Product Change Notification

(Notification – P2207047-DI)

(IMO-AB-22-0072-1 / PC-MCU-A005A/E)

This notification announces a change to the embossed tape (tape & reel) width of select RX100/200/600 devices in the 14x14mm LQFP package manufactured at Renesas Semiconductor (Beijing) Co., Ltd. (RSB). The tape width will change from 32mm to 24mm.

Appendix B: Change Summary

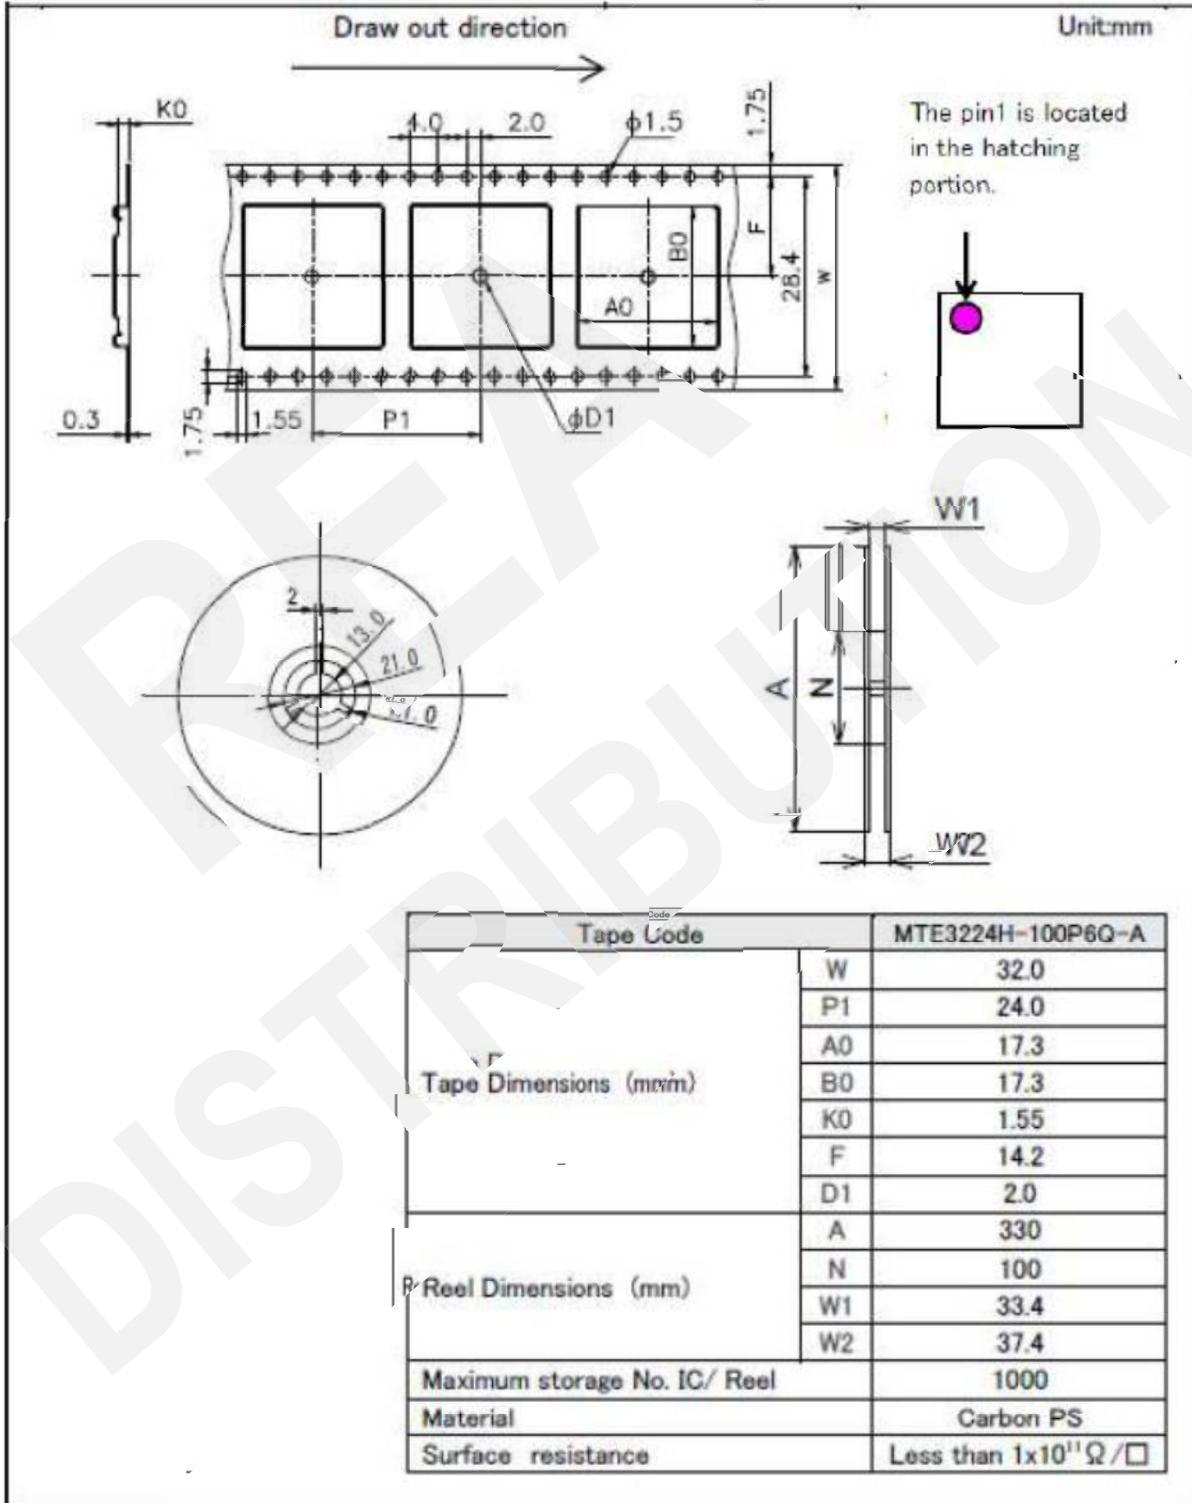
The pocket width, pocket depth, feed hole, dimension between feed hole and pocket center, reel width, and cover tape width change due to the change in tape width. See the appendix for details.

Packing material	Item	Before	After
Emboss tape	Taping code	MTE3224H-100P6Q-A	E2424Q14RA
	Sprocket hole	Both side	One side
	Tape width	32mm	24mm
	Tape thickness	0.3mm	0.3mm
	Cavity size	17.3 ⁿ 17.3	16.5x16.5
	Cavity depth	1.55 ^m mm	1.4mm
	Distance between cavity centers	24mm	24mm
	Material	PS	PS
Reel	Reel diameter	330mm	330mm
	Core diameter	100mm	100mm
	Reel width	For 32-mm width tape	For 24-mm width tape
